Product Change Notice (PCN)

PCN Number: PCN-0456173R-01

Product(s) Affected: PJ-040DH

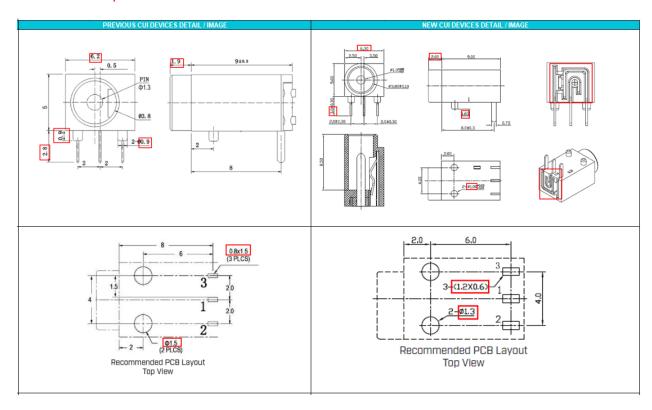
Description of Change: New Factory Location. Product re-engineered for improved manufacturability and production yield. See image below for reference and check CUI Devices website for updated drawing. Cosmetic differences may be visible and not affect the form fit and function of the product.

PREVIOUS CUI DEVICES DETAIL / IMAGE			NEW CUI DEVICES DETAIL / IMAGE		
DESCRIPTION	MATERIAL	PLATING/COLDR	DESCRIPTION	MATERIAL	PLATING/COLOR
center pin	brass	silver	center pin	brass	silver
terminal 1	brass t=0.25	silver	terminal 1	brass t=0.25	silver
terminal 2	brass :=0.25	silver	terminal 2	SUS301 t=0.25	silver
terminal 3	brass t=0.25	silver	terminal 3	brass t=0.25	silver
cover	PBT (UL94V-0)	black		PA66 UL94V-0)	black
housing	PBT (UL94V-0)	black	housing	PABB UL94V-UJ	DIACK
MATING PLUG Jack Insertion Depth: B.O mm			MATING PLUG Jack Insertion Depth B.5 mm
